Flight Procedures Cover Page	Task Action: FLIGHT CHECK	Task Type: STAR	Estimated Chart Date: 09/05/2024	APWS Task ID: 4FD78CE59C434CA88DE3FC3C6EA4FF80	APWS Project ID: 13FF286B992B4A9791BEAF097B2F54D4
Procedure: STAR ANTHM (RNAV) FOUR BALTIMORE MD KBWI		Enroute: YES	Specialist: Bradshaw, Henry		Agreement Number:
Airport ID: KBWI			Airport City: BALTIMORE		State: MD
Facility ID:	Facility Type:	Flight Inspection Remark Type: New FC Slot

PROCEDURE:	AIRPORT NAME:	AIRPORT ID:	SPECIAL CONTROL NO:
STAR ANTHM (RNAV) FOUR BALTIMORE MD KBWI	BALTIMORE/WASHINGTON INTL	KBWI	YG-03-262-24

Subject: Approval Request: Baltimore, MD (KBWI) ANTHM (RNAV) STAR

(BUBBI.ANTHM4) FIG
ANTHM FOUR ARRIVAL (RNAV) Arrival Routes

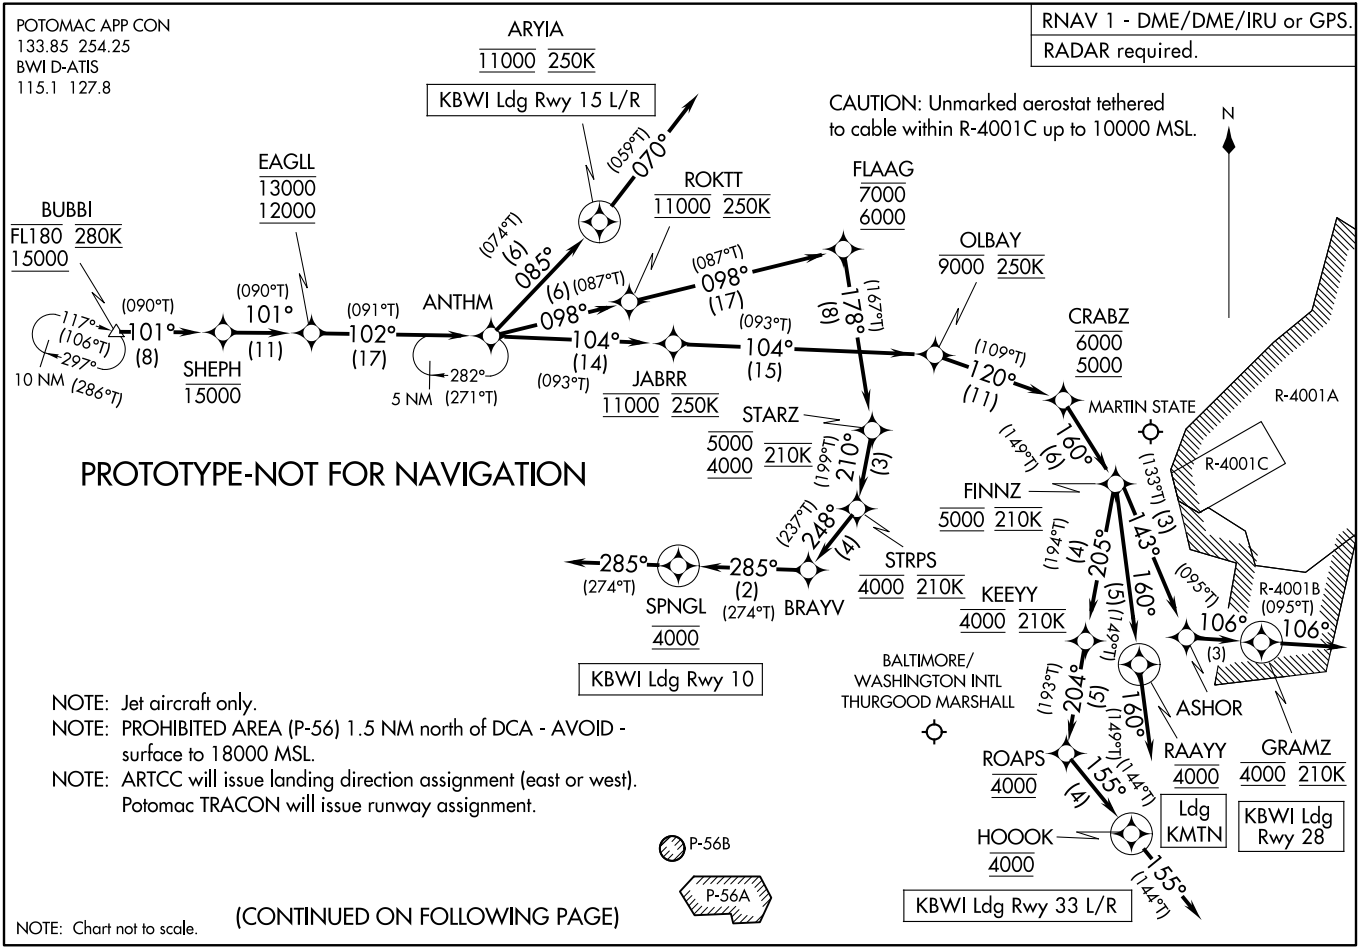
RSO179: [Approval Required] The length of the leg from FLAAG to STARZ is 7.76NM. This leg must be at least 12.0 NM long due to deceleration from 250.0 KIAS to 210 KIAS between 6000.0 ft. MSL to 4000.0 ft. MSL. Flight Standards approval is required.

The segment with the restrictions of at 11000 at ROKTT 250KIAS followed by cross STARZ between 4000/5000 and 210KIAS requires a 12 NM length, per the 8260.3F paragraph 2-2-10 a, for a reduction of 10- 40Kts. The deceleration required by the ROKTT-STARZ segment is 40 Kts. The reduction from 250 Kts to 210 Kts from ROKTT to STARZ is 5.86 NM. The previous fix ANTHM has no restrictions therefore the aircraft will be at or below 250 KIAS 17.65 NM prior to reaching STARZ. The distance from ANTHM to STARZ is 30.66 NM allowing ample distance to reduce speed to 210 KIAS. The KBWI ANTHM STAR has been in publication for several years and there have been no instances where aircraft could not make this restriction reported.

RSO144: [Approval Required] The Descent Gradient (343.21) from LUNDY to CURBY is greater than the Maximum Permissible Descent Gradient (330.0).

A computed descent gradient value from LUNDY to CURBY of 343.21 ft./NM resulted from the descent gradient being calculated from descending from the restriction of At FL290 at LUNDY (FL290 used) to cross CURBY AOB FL240 and At or ABOVE FL210 (FL240 B FL210) over 46.09 NM. The restriction after CURBY is at BUBBI, a restriction of AOB FL180 and AOA 15000 (FL180N15000). The restriction after BIBBI is AOB 15000 at SHEPH then AOB13000 and AOA12000 (13000B12000) at EAGLL and 11000 at JABRR then AOB 9000 at OLBAY. The distance required to descend from LUNDY at FL290 to OLBAY at 9000 is 111.26 NM. Calculating a descent gradient from LUNDY to OLBAY 111.26 NM resulted in a descent gradient of 329.4 ft./NM.

RSO144: [Approval Required] The Descent Gradient (363.99) from OLBAY to CRABZ is greater than the Maximum Permissible Descent Gradient (318.0)

A computed descent gradient value from OLBAY to CRABZ of 363.99 ft./NM resulted from the descent gradient being calculated from descending from the restriction of AOB 9000 at OLBAY to cross CRABZ AOB 6000 and AOA 5000 (6000 B 5000) over 10.99 NM. The restriction after CRABZ is at FINNZ, a restriction of AT 5000. The distance required to descend from OLBAY at 9000 to FINNZ at 5000 is 16.68 NM. Calculating a descent gradient from OLBAY to FINNZ resulted in a descent gradient of 239.80 ft./NM.

Consideration was given to removing and or changing the restrictions at ROKTT and or STARZ. However, to allow aircraft to be configured for the segments following STARZ restrictions remained unchanged since there has never been a reported difficulty and was not an impediment to the safety or profile of the procedure.

Consideration was given to removing and or changing the restrictions at LUNDY, CURBY, SHEPH, EAGLL, JABRR and OLBAY. However, due to airspace constraints and traffic flows it was decided that the restrictions are necessary to prevent aircraft from entering adjacent airspace, prevent conflictions from other traffic and procedures, and reduce ATC workload due to required coordination, (point outs).

Consideration was given to removing and or changing the restrictions at OLBAY, CRABZ and FINNZ. However, due to airspace constraints and traffic flows it was decided that the restrictions are necessary to prevent aircraft from entering adjacent airspace, prevent confliction from other traffic and procedures, and reduce ATC workload due to required coordination, (point outs).
